RECAPP Facility Evaluation Report

Mayerthorpe Jr. / Sr. High School

B3754A
Mayerthorpe

Evaluation Company: Francis Ng Architect Ltd.
Evaluation Date: October 4 2006
Evaluator Name: Francis Ng

Event: Study on concrete block wall cracks.

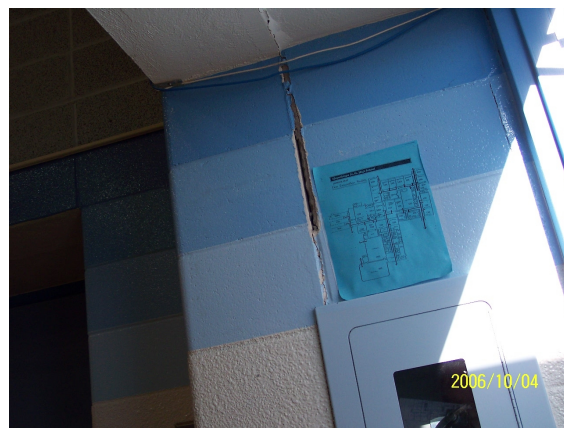
(1992) Addition - (wall opening connecting GYM 116) has cracked concrete blocks.

Further engineering study on concrete block wall cracks.
